Access Audit Site Report

Palo Duro Canyon State Park
11450 State Hwy Park Rd 5
Canyon, TX 79015
Accessibility Evaluation
Inspection Date: 08/10/2021
Inspectors: Tanya Scheibe

Prepared By
WT Group

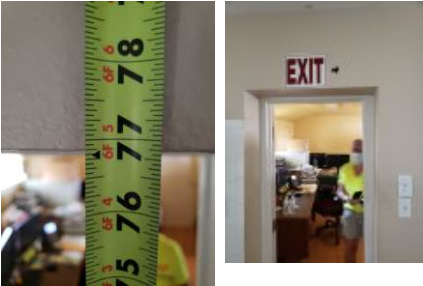
Finding Number	Area Description	Lat/Long	Finding	As Built	Recommendation	Citation	Photos	Figure
6	Headquarters: Headquarters EAR	[34.9854965 , -101.7018 605], [34.985347, -101.70196 24]	The building entrance is not located on an accessible route. When a building, or portion of a building, is required to be accessible, an accessible route of travel shall be provided to all portions of the building, to accessible building entrances and between the building and the public way. All walks, halls, corridors, aisles, skywalks, tunnels, and other spaces that are part of an accessible route must comply. An accessible route of travel must not pass through kitchens, storage rooms, restrooms, closets or other spaces used for similar purposes. At least one accessible route within the boundary of the site must be provided from public transportation stops, accessible parking and accessible passenger loading zones and public streets or sidewalks to the accessible building entrance they serve. The accessible route shall, to the maximum extent feasible, coincide with the route for the general public. At least one accessible route shall connect accessible buildings, facilities, elements and spaces that are on the same site. At least one accessible route shall connect accessible building or facility entrances with all accessible spaces and elements.	admin building: steps only to entrance, plants blocking path, cracks in sidewalk	Resurface route from parking to entry and ramp steps for access.	2015 ABAAS Section: F206.2.1 2012 TAS Section: 206.2.1 2010 ADAS Section: 206.2.1

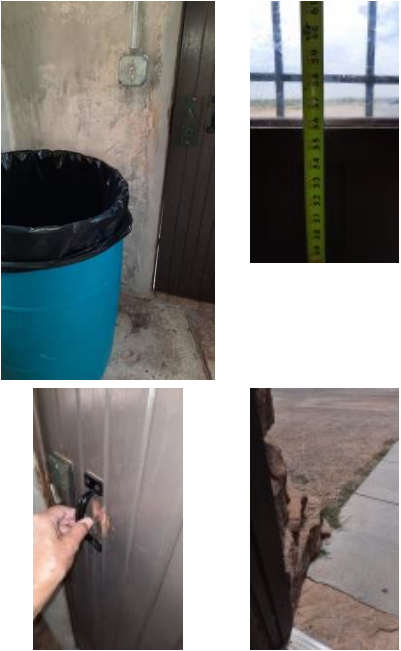
Finding Number	Area Description	Lat/Long	Finding	As Built	Recommendation	Citation	Photos	Figure
16	Headquarters: Headquarters Public Spaces	[34.9847163 , -101.7018 404]	The transaction counter is too high. A portion of the counter surface that is 36 inches long minimum and 36 inches high maximum above the finish floor shall be provided. Knee and toe space must be provided for a forward approach. A 30 inch by 48 inch clear floor space on an accessible route must be provided for either a forward or parallel approach.	service counter at check-in - 43.25" above finished floor	Lower 36" wide segment of service counter to max 36" aff.	2015 ABAAS Section: 904.4.2, 904.4.1 2012 TAS Section: 904.4.1, 904.4.2 2010 ADAS Section: 904.4.2, 904.4.1		
17	Headquarters: Headquarters Restrooms	[34.9848592 , -101.7015 843]	Where a high forward reach is over an obstruction, the clear floor space shall extend beneath the element for a distance not less than the required reach depth over the obstruction. The high forward reach shall be 48 inches (1220 mm) maximum where the reach depth is 20 inches (510 mm) maximum. Where the reach depth exceeds 20 inches (510 mm), the high forward reach shall be 44 inches (1120 mm) maximum and the reach depth shall be 25 inches (635 mm) maximum. Where a clear floor or ground space allows a parallel approach to an element and the high side reach is over an obstruction, the height of the obstruction shall be 34 inches (865 mm) maximum and the depth of the obstruction shall be 24 inches (610 mm) maximum. The high side reach shall be 48 inches (1220 mm) maximum for a reach depth of 10 inches (255 mm) maximum. Where the reach depth exceeds 10 inches (255 mm), the high side reach shall be 46 inches (1170 mm) maximum for a reach depth of 24 inches (610 mm) maximum.	Men's RR - hand dryer and soap dispenser mounted 51" above finished floor	Lower operating mechanisms to max 48" aff to highest operable part.	2015 ABAAS Section: 308.2.1, 308.3.2 2012 TAS Section: 308.2.1, 308.3.2 2010 ADAS Section: 308.2.1, 308.3.2

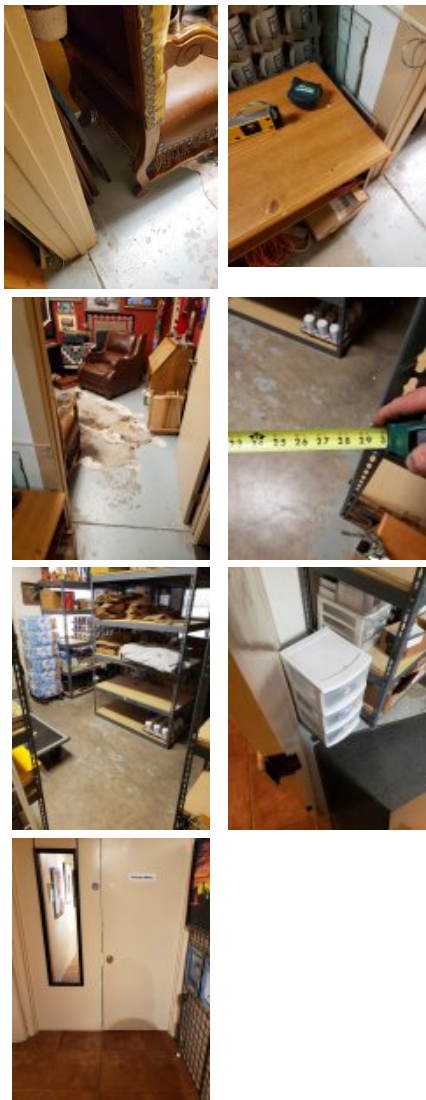
Finding Number	Area Description	Lat/Long	Finding	As Built	Recommendation	Citation	Photos	Figure
27	Headquarters: Headquarters Restrooms	[34.984857, -101.70158 29]	Minimum maneuvering clearances at doors and gates shall comply with 404.2.4. Maneuvering clearances shall extend the full width of the doorway and the required latch side or hinge side clearance. Exterior doors are recommended to be maintained at 8.5 lbf as a smart practice. Force is to be measured at the operating hardware or 30 inches from the hinges, whichever is greater. Hand-activated door opening hardware, handles, pulls, latches, locks, and other operating devices on accessible doors shall have a shape that is easy to grasp with one hand and does not require tight grasping, tight pinching or twisting of the wrist to operate. Hardware shall be 34 inches minimum and 48 inches maximum above the finish floor or ground. Doors, gates, and side lights adjacent to doors or gates, containing one or more glazing panels that permit viewing through the panels shall have the bottom of at least one glazed panel located 43 inches (1090 mm) maximum above the finish floor. EXCEPTION: Vision lights with the lowest part more than 66 inches (1675 mm) from the finish floor or ground shall not be required to comply with 404.2.11.	restroom building entry - garbage in pull side maneuvering clearance, window 56" above ground, small hardware requires a pinch, stone wall on push side maneuvering clearance, 16 lb of force to open	For all doors along the public circulation route, provide required maneuvering clearance on push and pull side of doors For all doors along the public circulation route, inspect, adjust, and maintain 8.5 lbf to open exterior doors as a smart practice For all doors along the public circulation route, replace hardware with lever hardware or hardware operable without a tight pinch or grasp For all doors along the public circulation route, replace doors with ones having sidelight viewing windows max 43" aff	2010 ADAS Section: 404.2.3, 404.2.7, 404.2.4, 404.2.11, 404.2.11 Exception

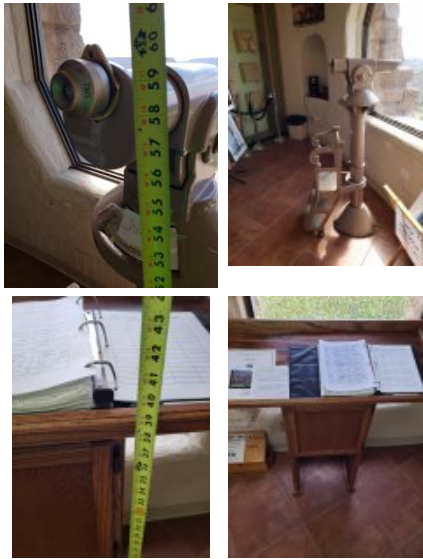
Finding Number	Area Description	Lat/Long	Finding	As Built	Recommendation	Citation	Photos	Figure
28	Rim Cabins: Cabin	[34.9795152 , -101.6931 993], [34.9791965 , -101.6922 243]	There is no accessible route to the cabins. At least one accessible route shall connect accessible buildings, accessible facilities, accessible elements, and accessible spaces that are on the same site.	3 rim cabins down steep stairs, inaccessible entry	Leave as is rim cabins - infeasible to create access to these sites.	2015 ABAAS Section: F206.2.2 2012 TAS Section: 206.2.2 2010 ADAS Section: 206.2.2

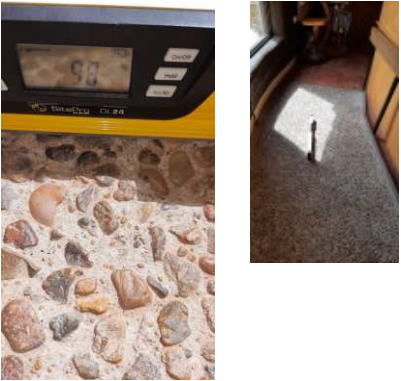
Finding Number	Area Description	Lat/Long	Finding	As Built	Recommendation	Citation	Photos	Figure
34	Visitor Center: Visitor Center EAR	[34.979253, -101.6914106]	The route of travel at this location does not provide the required minimum width. The minimum clear width for sidewalks and walks is 36 inches.	route along building 29" wide, 4% cross slope, not accessible; mount signage	Mount signage along this route directing patrons with disabilities to an accessible route.	2015 ABAAS Section: 403.5.1 2012 TAS Section: 403.5.1 2010 ADAS Section: 403.5.1		
35	Visitor Center: Visitor Center EAR	[34.9792497, -101.6915233]	The accessible route contains loose gravel and/or surface materials that do not provide for a stable, firm slip resistant surface.	surface around benches covered in sand	Train staff to maintain surface at benches to be free of sand and debris.	2015 ABAAS Section: 302.1 2012 TAS Section: 302.1 2010 ADAS Section: 302.1

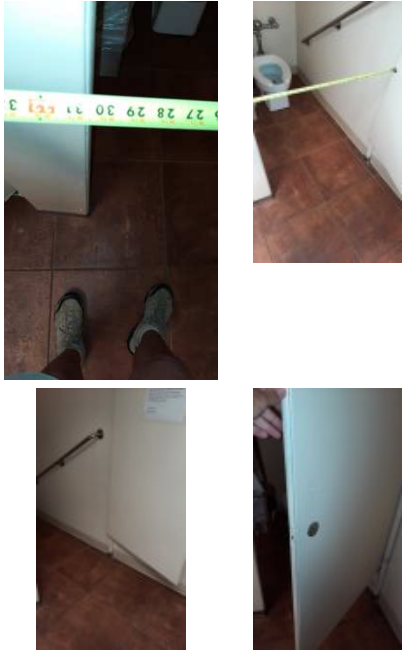
Finding Number	Area Description	Lat/Long	Finding	As Built	Recommendation	Citation	Photos	Figure
53	Visitor Center: Visitor Center Public Spaces	[34.9791959 , -101.6915 407]	The ramp run has not been provided with edge protection. The floor or ground surface of the ramp run or landing shall extend 12 inches minimum beyond the inside face of a handrail or a curb or barrier shall be provided that prevents the passage of a 4 inch diameter sphere, where any portion of the sphere is within 4 inches of the finish floor or ground surface.	Interior ramp- lacks edge protection	Install rail along bottom edge of ramp that prevents a 4" sphere from passing through.	2015 ABAAS Section: 405.9, 405.9.1, 405.9.2 2012 TAS Section: 405.9.1, 405.9.2, 405.9 2010 ADAS Section: 405.9.2, 405.9.1, 405.9		
54	Visitor Center: Visitor Center Public Spaces	[34.9791915 , -101.6915 367]	The sign extends down too close to the route of travel. Any obstruction that overhangs a route of travel must be a minimum of 80 inches above the walking surface as measured from the bottom of the obstruction.	sign at hanging 79" above finished floor near restroom	Raise sign to min 80".	2015 ABAAS Section: 307.4 2012 TAS Section: 307.4 2010 ADAS Section: 307.4

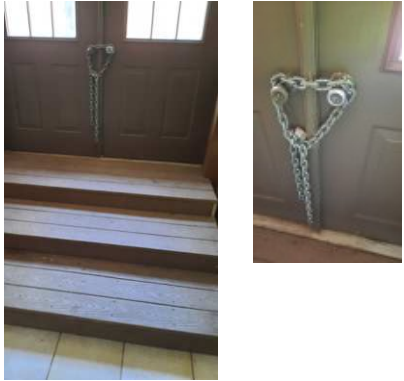
Finding Number	Area Description	Lat/Long	Finding	As Built	Recommendation	Citation	Photos	Figure
122	Pioneer Amphitheater: Pioneer Amphitheater EAR	[34.9760806, -101.6797243]	The ramp does not have compliant handrails. Handrails are required on both sides of all surfaces that are sloped greater than 5 percent (1:20). Handrails must be between 34 inches and 38 inches above the ramp surface, must extend beyond the top and bottom of the ramp 12 inches and be parallel to the floor or ground surface. The diameter of the handrails must be between 1 inches and 2 inches in cross-sectional nominal dimension for circular handrails and handrail gripping surfaces with a non-circular cross section shall have a perimeter dimension of 4 inches minimum and 6 inches maximum, and a cross-section dimension of 2 inches maximum. The clear space between handrails and walls must 1-1/2 inches minimum.	amphitheater - ramp from restroom to seating lack handrails	Install handrails that are rounded and/or extend to the ground, with handrail extensions and mounted 34" to 38" aff	2015 ABAAS Section: 505.1 2012 TAS Section: 505.1 2010 ADAS Section: 505.1

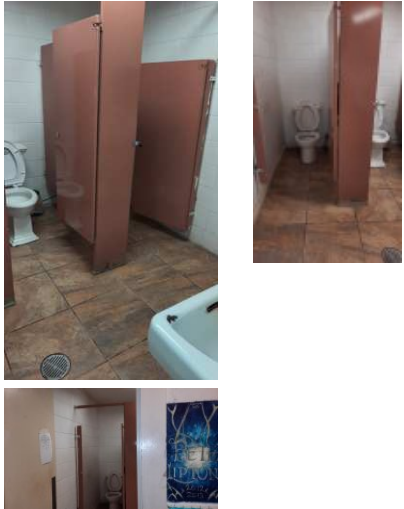
174	Pioneer Amphitheater: Pioneer Ampitheater Restrooms - Men's	[34.9750597, -101.6790617]	The required 56 inches by 60 inches clear floor space for the water closet has been obstructed. The clear floor space around the water closet shall be 60 inches minimum measured perpendicular from the side wall and 56 inches minimum measured perpendicular from the rear wall.	children boys dressing room - sink 56" from wall	Relocate sink to provide required 60" clearance around toilet, in the alternative, leave as is citing safe harbor.	2015 ABAAS Section: 604.3. 2012 TAS Section: 604.3.1 2010 ADAS Section: 604.3.1

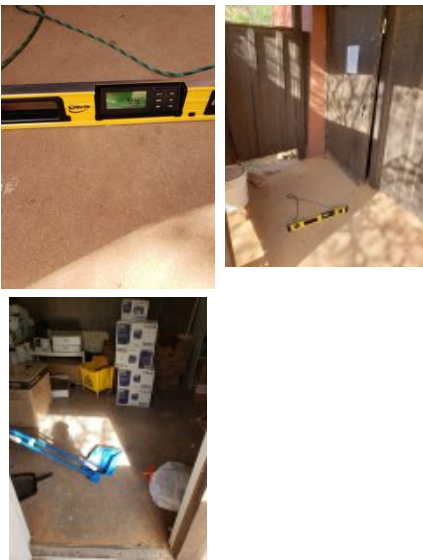
183	Pioneer Amphitheater: Pioneer Amphitheater Employee Spaces	[34.9752729 , -101.6790 671]	The threshold has a vertical change greater than 1/4 inch high. Hand-activated door opening hardware, handles, pulls, latches, locks, and other operating devices on accessible doors shall have a shape that is easy to grasp with one hand and does not require tight grasping, tight pinching or twisting of the wrist to operate. Hardware shall be 34 inches minimum and 48 inches maximum above the finish floor or ground.	dressing room exit - 1.5" change in level, knob hardware	For all doors along the public circulation route, repair, bevel, or ramp CILs at door entries to max .25" For all doors along the public circulation route, replace hardware with lever hardware or hardware operable without a tight pinch or grasp	2010 ADAS Section: 404.2.3, 404.2.7, 404.2.4, 404.2.11, 404.2.11 Exception

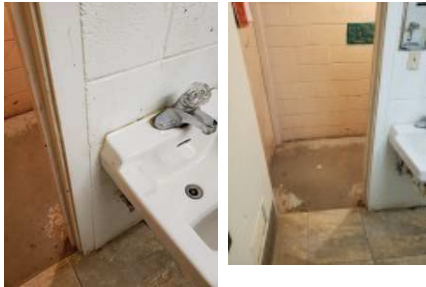
188	Pioneer Amphitheater: Pioneer Amphitheater Employee Spaces	[34.9752839 , -101.6790 671]	Minimum maneuvering clearances at doors and gates shall comply with 404.2.4. Maneuvering clearances shall extend the full width of the doorway and the required latch side or hinge side clearance.	Men's dressing room exit - tables in pull side clearance and narrow pad.	Provide required maneuvering clearance around pull side of door Relocate storage, furniture and other obstacles to create 60" maneuvering clearance around door	2015 ABAAS Section: 404.2.4.1 , 404.2.4.4 2012 TAS Section: 404.2.4.4, 404.2.4.1 2010 ADAS Section: 404.2.4.4, 404.2.4.1

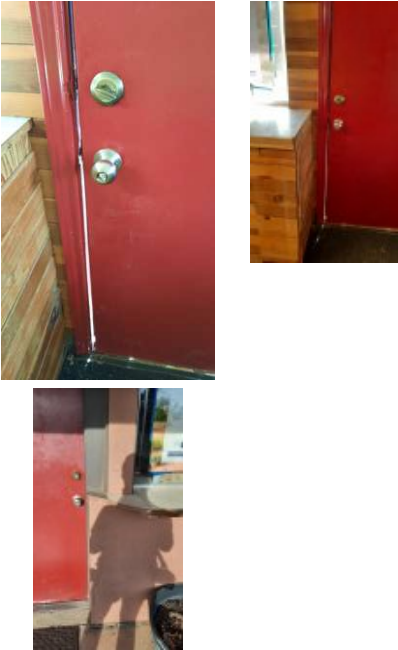
Finding Number	Area Description	Lat/Long	Finding	As Built	Recommendation	Citation	Photos	Figure
241	Old West Stables: Old West Stables Parking	[34.9721234 , -101.6782 678]	There are no accessible parking stalls. Each lot where parking is provided for the public as clients, guests or employees, shall provide accessible parking and shall be located on the shortest accessible route of travel from adjacent parking to an accessible entrance. There are a total of 25 parking stalls in the parking lot that could be reasonably associated with this facility. There should be a minimum of one accessible stalls with a minimum of one being designed as van accessible.	0 accessible parking stalls, approximately 25 plus parking spots. No striping	Create one or more 8' accessible parking stalls, with one 5' adjacent access aisle, with proper signage and striping based on the total number of stalls	2015 ABAAS Section: F208.2 2012 TAS Section: 208.2 2010 ADAS Section: 208.2

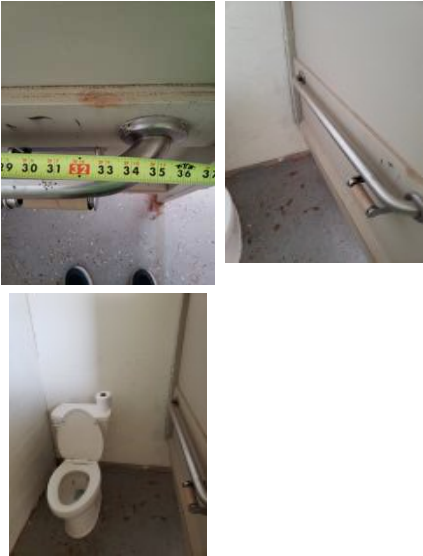
255	Old West Stables: Old West Stables Public Spaces	[34.9719036 , -101.6784 234]	There is insufficient turning space within this room or space. The space required for a wheelchair to make a 180-degree turn is a clear space of 60 inches in diameter or a T-shaped space.	bunk - furniture reduces clear space	Relocate obstacles to create turning space in bunk	2015 ABAAS Section: 304.3.1, 304.3.2 2012 TAS Section: 304.3.1, 304.3.2 2010 ADAS Section: 304.3.1, 304.3.2

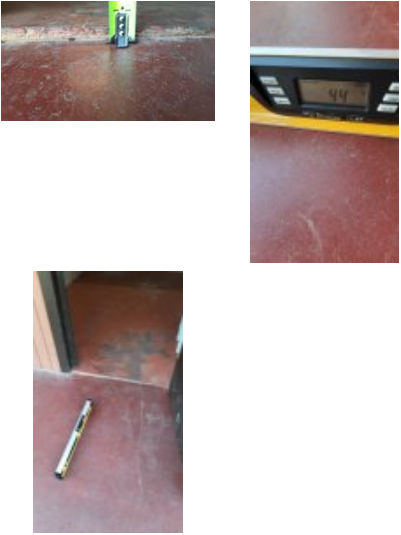
277	Hackberry Camp Area: Hackberry Camp Area - E. Restroom Parking/Exterior Route	[34.9677693, -101.6716213]	There are no accessible parking stalls. Each lot where parking is provided for the public as clients, guests or employees, shall provide accessible parking and shall be located on the shortest accessible route of travel from adjacent parking to an accessible entrance. There are a total of 4 parking stalls in the parking lot that could be reasonably associated with this facility. There should be a minimum of 1 accessible stalls with a minimum of 1 being designed as van accessible.	east restroom bldg - 4 stalls, none accessible	Create one or more 8' accessible parking stalls, with one 5' adjacent access aisle, with proper signage and striping based on the total number of stalls	2015 ABAAS Section: F208.2 2012 TAS Section: 208.2 2010 ADAS Section: 208.2

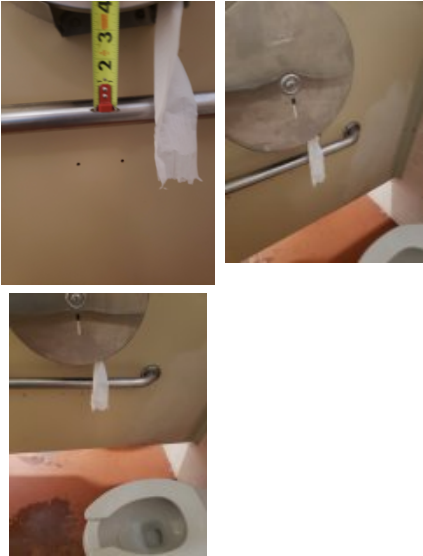
289	Hackberry Camp Area: Hackberry Camp Area Restrooms East	[34.967666, -101.6716267]	The accessible route contains running slopes greater than 5 percent and cross slopes greater than 2 percent across the width of the walk and has not been constructed as a ramp (i.e. handrails, wheel guides, etc.). When the slope in the direction of travel of any walk exceeds 1 unit vertical in 20 units horizontal (5-percent slope), it must be constructed as ramp. Surface cross slopes must not exceed one unit vertical in 48 units. Horizontal (2-percent slope).	Women's restroom - 4% slope at drain	Correct or repair slope to max 2.08%.	2015 ABAAS Section: 403.3 2012 TAS Section: 403.3 2010 ADAS Section: 403.3

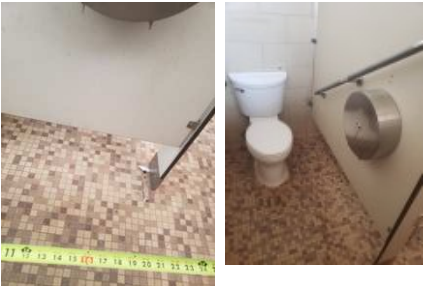
309	Hackberry Camp Area: Hackberry Camp Area Restrooms West	[34.9676748 , -101.6716 106]	The water and drain pipes under the lavatory are not adequately insulated. Water supply and drain pipes under lavatories and sinks shall be insulated or otherwise configured to protect against contact. There shall be no sharp or abrasive surfaces under lavatories and sinks.	Women's restroom - sink pipes lack insulation	Insulate exposed pipes under one sink.	2015 ABAAS Section: 606.5 2012 TAS Section: 606.5 2010 ADAS Section: 606.5

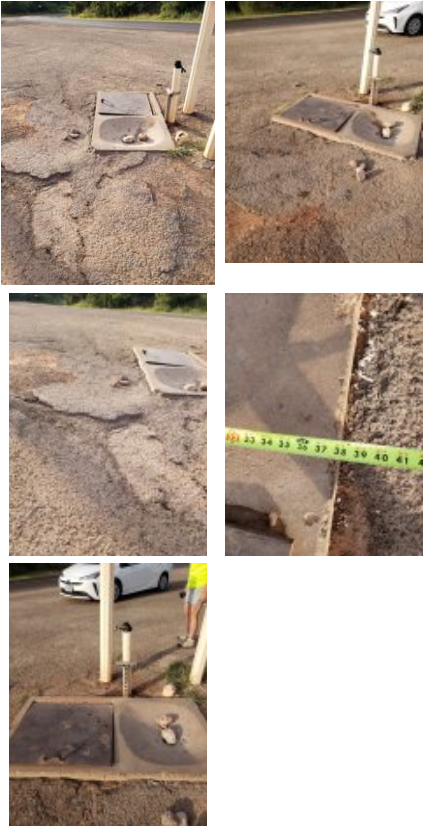
312	Hackberry Camp Area: Hackberry Camp Area Restrooms West	[34.9662329, -101.6716052]	The toilet is not located within the range to the side wall or partition. The centerline of the toilet shall be 17 inches minimum and 19 inches maximum side wall or partition in the ambulatory accessible toilet compartment.	Women's restroom - toilet centerline 20.25" from side wall	Remount toilet to 17" to 19" from the side wall to center line in ambulatory stalls, or 16" to 18" for new wheelchair stall.	2015 ABAAS Section: 604.9.1 2012 TAS Section: 604.9.1 2010 ADAS Section: 604.9.1

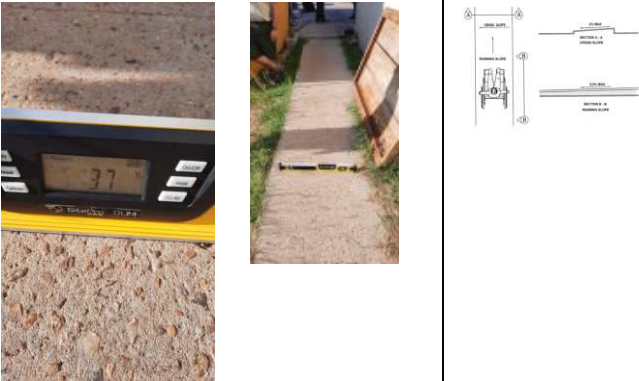
Finding Number	Area Description	Lat/Long	Finding	As Built	Recommendation	Citation	Photos	Figure
450	Tasajillo Pavilion : Public Space	[34.9376555 , -101.6484 846]	Exterior doors exceed 8.5 lbs of force to open; fire doors shall have a minimum opening force allowable by the appropriate administrative authority	4 sets of double doors, starting from maintenance closet: 15#, 14#, 13#, 13# (sticks), 12#, 13#, 14#, 14#, measured in lbs of force to open. Push bar difficult on most doors	Inspect, adjust, and maintain 8.5 lbf to open exterior doors as a smart practice	2010 ADAS Section: 404.2.9		
451	Tasajillo Pavilion : Public Space	[34.97193, -101.6783]	Element meets all standards and requirements	grill and fire ring comply - on accessible route	None	2010 ADAS Section: N/A		
452	Tasajillo Pavilion : Employee Space	[34.9376577 , -101.6484 792]	Spaces and elements within employee work areas shall only be required to comply with 206.2.8, 207.1, and 215.3 and shall be designed and constructed so that individuals with disabilities can approach, enter, and exit the employee work area. Employee work areas, or portions of employee work areas, other than raised courtroom stations, that are less than 300 square feet (28 m2) and elevated 7 inches (180 mm) or more above the finish floor or ground where the elevation is essential to the function of the space shall not be required to comply with these requirements or to be on an accessible route.	Janitor and storage - counter at 14" on pull at both	For employee spaces, relocate storage, furniture, and other obstacles at doorways to provide approach, enter and exit at the employee space.	2015 ABAAS Section: F203.9 2012 TAS Section: 203.9 2010 ADAS Section: 203.9

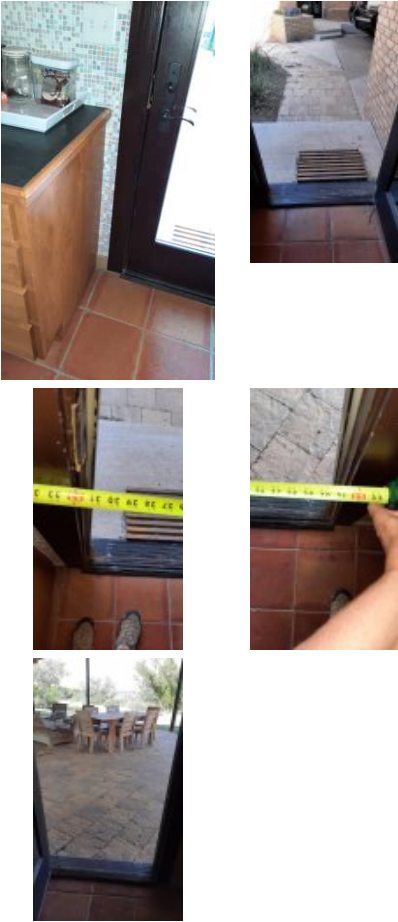
484	Canoncita: Retreat Center	[34.8801871 , -101.6576 416]	Minimum maneuvering clearances at doors and gates shall comply with 404.2.4. Maneuvering clearances shall extend the full width of the doorway and the required latch side or hinge side clearance. Hand-activated door opening hardware, handles, pulls, latches, locks, and other operating devices on accessible doors shall have a shape that is easy to grasp with one hand and does not require tight grasping, tight pinching or twisting of the wrist to operate. Hardware shall be 34 inches minimum and 48 inches maximum above the finish floor or ground.	Inaccessible entry-pinch hardware, wood mat in door clearance	For all doors along the public circulation route, provide required maneuvering clearance on push and pull side of doors, remove mat from door clearance. For all doors along the public circulation route, replace hardware with lever hardware or hardware operable without a tight pinch or grasp	2010 ADAS Section: 404.2.3, 404.2.7, 404.2.4, 404.2.11, 404.2.11 Exception

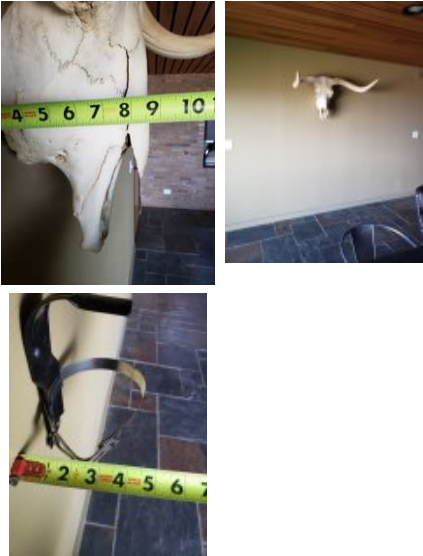
Finding Number	Area Description	Lat/Long	Finding	As Built	Recommendation	Citation	Photos	Figure
490	Canoncita: Retreat Center	[34.8801871 , -101.6576 416]	Knee clearance at 27 inches off the floor is not 8 inches minimum deep. The knee clearance, measured from the bottom of the apron or the outside bottom edge of the lavatory, must be 27 inches at a point located 8 inches back from the front edge and continuing to 11 inches minimum in depth at 9 inches above the floor. The top of the lavatory rim may be no higher than 34 inches.	Main Building Restroom - garbage in toe clearance	Remove garbage can from toe clearance at sink.	2015 ABAAS Section: 306.3.1, 306.3.2, 306.3.3, 306.3.4 , 306.3.5 2012 TAS Section: 306.3.2, 306.3.3, 306.3.4, 306.3.5, 306.3.1 2010 ADAS Section: 306.3.3, 306.3.2, 306.3.4, 306.3.5, 306.3.1		
491	Canoncita: Retreat Center	[34.8801871 , -101.6576 416]	The toilet is not located within the range allowed from the side wall or partition. The centerline of the toilet must be 16 to 18 inches from the side wall.	Main Building Restroom - 18.5" to centerline from wall	Centerline of toilet is 18.5" from wall, should not exceed 18", leave as is citing construction tolerance.	2015 ABAAS Section: 604.2 2012 TAS Section: 604.2 2010 ADAS Section: 604.2
